Memorandum

DATE: August 22, 2025

RE: IMM Comments on 2026 AS Methodology

Figure 2: Annual Probability of Firm Load Shed and entering Watch Conditions

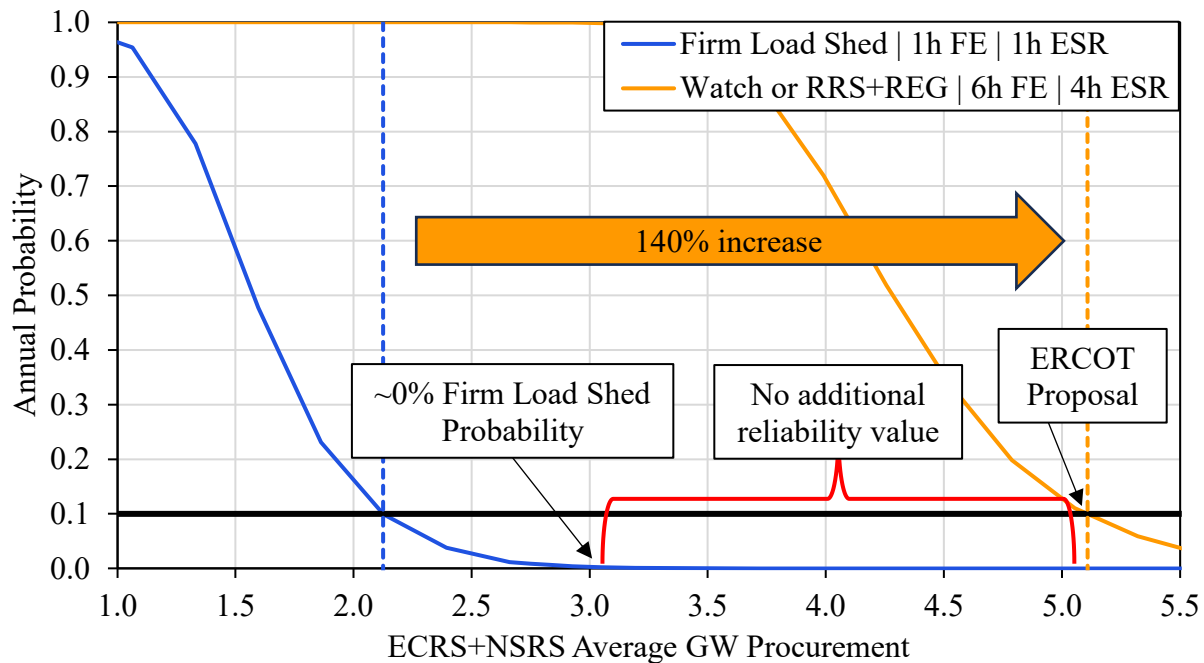
Together, these inputs result in the proposed AS Methodology that procures 140% more than what is required to satisfy the 1-in-10 reliability standard for load shed, *the last 2 GW of which provide no additional reliability*. This is illustrated in the following figure. The blue curve represents the probability of firm load shed at different procurement levels of ECRS and NSRS. This curve reflects the IMM base case and uses a one hour load forecast error and a one hour duration requirement for energy storage resources. The orange curve reflects the probability of

entering a Watch condition at different procurement levels of ECRS and NSRS and uses the ERCOT base case of a six hour load forecast error and a four hour duration requirement for energy storage resources. The procurement level required to achieve a one-in-ten (or 10%) probability of each outcome is identified by the intersection of horizontal black line with these two curves.

This figure shows that the level of total ECRS and NSRS needed to meet the one-in-ten (0.1 probability) reliability standard would average roughly 2.1 GW. In contrast, ERCOT's proposal would procure 5.1 GW of reserves, approximately 2 GW of which would have no reliability value.

Together, this AS Plan is 140% larger than the IMM base case which achieves a 1-in-10 yearly probability of load shed. The last 2 GW of this plan provide no additional reliability value on average, as illustrated in Figure 2 (the same figure presented in the executive summary). We recommend that ERCOT revise their AS Methodology and consider operating reserve targets that reflect the reliability value they provide in mitigating real-time operational risks. The remainder of these comments detail our concerns with each of these parameters. A summary of

- A 3-hour forecast horizon for determining the target volumes for NSRS.
- Using a 1-in-10 criteria based on the LOLP curve in place of the Watch criteria.
- Using a 1-hour discharge horizon for ESRs rather than 4 hours.

Figure 1: Reserve Requirements Across Various US Electricity Markets

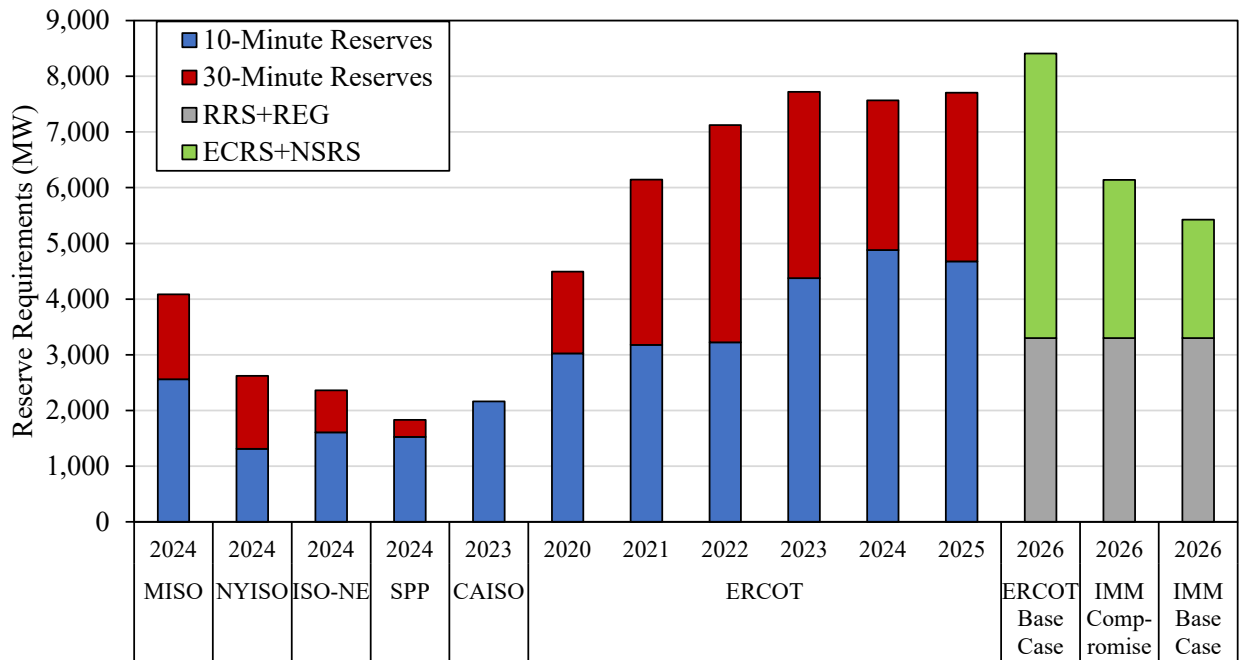
ERCOT procures significantly more 10 minute and 30 minute reserves than other ISOs.

Figure 3: Annual duration of PRC less than 3,000 MW between 2016 and 2025

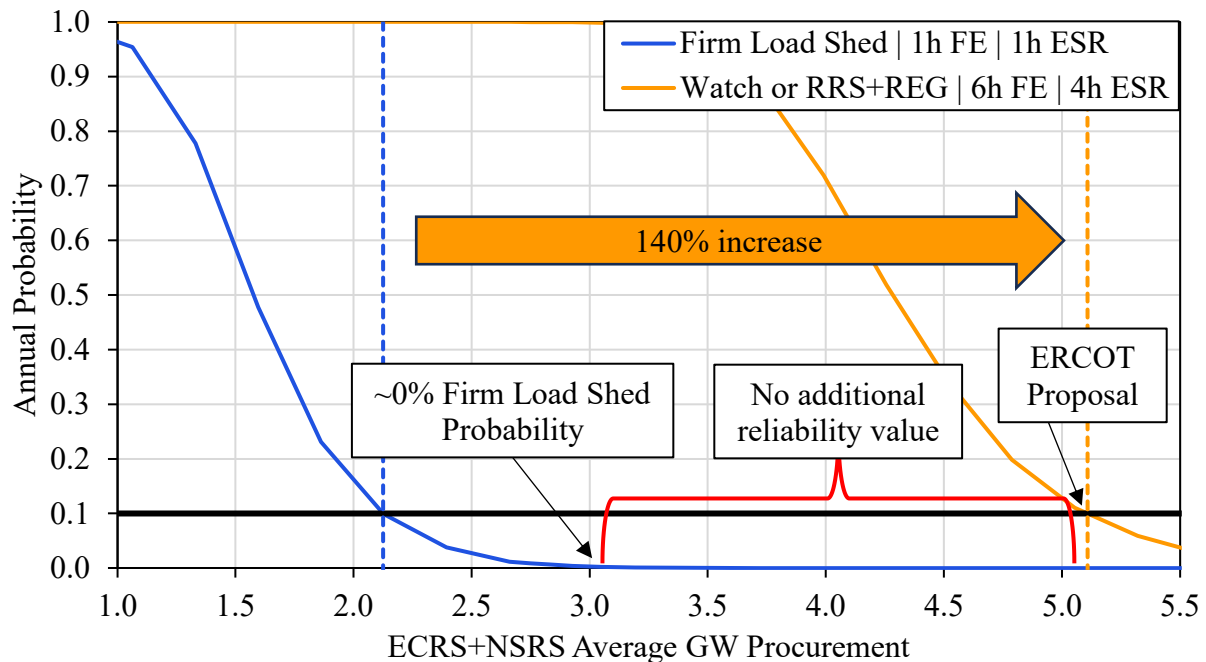
Prior to Winter Storm Uri, ERCOT had a policy of issuing a voluntary conservation notice referred to as a Watch whenever operating reserves dropped below 3,000 MW. Such events were relatively commonplace, with an average of 82 hours per year with PRC below 3,000 MW for 2016-2020, as shown in Figure 3. The aftermath of Winter Storm Uri shone a spotlight on the reliability of the ERCOT grid and, given the recent legislative session and a gubernatorial election around the corner, it was decided that avoiding Watch conditions was of paramount importance. Thus, Conservative Operations was born, the primary feature of which was to run the system with a high level of operating reserves, whether procured through RUC or through the AS Methodology, as discussed in more detail in the following section.

For the five years before Winter Storm Uri, PRC dropped below 3,000 MW for 82 hours on average every year.

Figure 4: Resource Availability Across Response Time Intervals

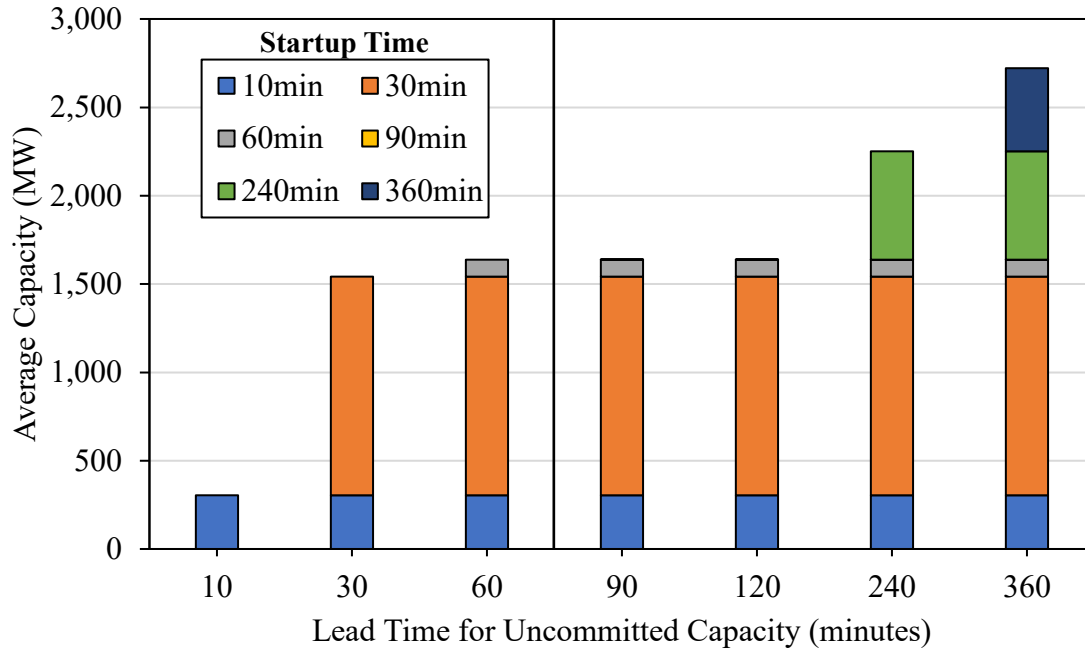
The cumulative capacity of reserves available to start under tight system conditions (PRC < 5,000 MW) includes more than 1,500 MW of capacity capable of starting in an hour or less.

Figure 5: Net Load Forecast Error Across Different Time Horizon Durations

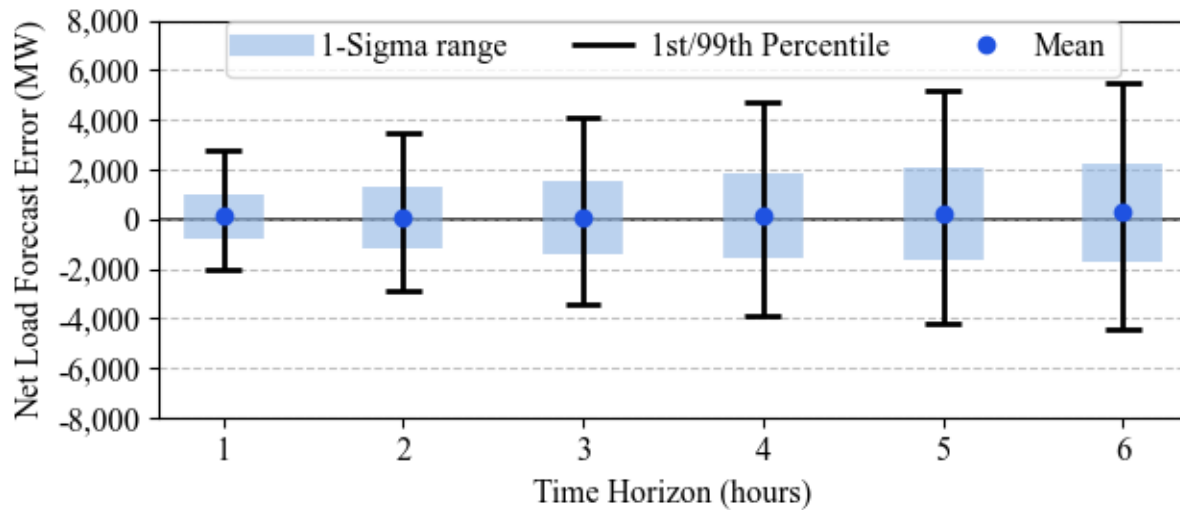
All inputs to the risk assessment should be based on the operational risks that the product is meant to manage. NSRS, for example, is designed to mitigate the risks associated with forced outages or forecast errors over a time horizon of approximately one hour. In the event of such risks manifesting themselves, market pricing should be sufficient to incentivize commitment of offline resources to maintain the reliability of the system. Our analysis has consistently shown that ERCOT has significant capacity from offline reserves that can start in an hour or less under tight system conditions, as illustrated in Figure 4. These conditions produce higher prices which in turn elicit a market response of self-commitment from available off-line resources. Setting this parameter to six hours nearly doubles the perceived risk associated with forecast error, as shown in Figure 5. This parameter effectively assumes that none of the offline capacity will self-commit in response to evolving system conditions, which is contrary to historical experience.

ERCOT's operational history demonstrates that six hours is an unnecessarily long time-horizon to run the system reliably. From 2016 to 2022, the methodology for determining the target volumes for NSRS used a three hour ahead forecast error. Over that time, there was no firm load shed caused by a lack of sufficient NSRS.

Forecast error risk is nearly twice as high six hours ahead as one hour ahead, ignoring the likelihood of self-commitment from quick-start resources.

Figure 6: RUC Commitments Between 2016 and 2024

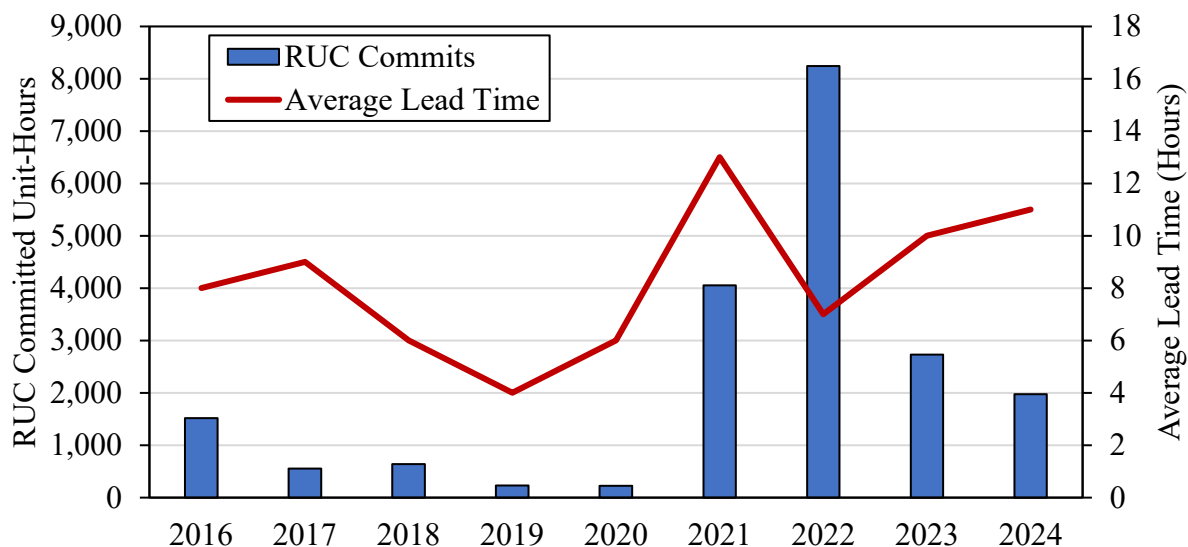
Figure 6 shows the increase in the unit hours of resources committed through RUC and the increase in the average lead time between the commitment instruction and real-time. The

following year, to achieve its desired level of operating reserves through the market rather than through overreliance on RUC, ERCOT increased the time horizon used for calculating forecast error in the NSRS methodology to six hours. Thus, *the methodology followed from the operational paradigm*, which itself was not supported by sound reliability criteria.

After Winter Storm Uri in 2021, the frequency of RUC commits increased substantially, and the average RUC instruction was given further in advance of real-time.
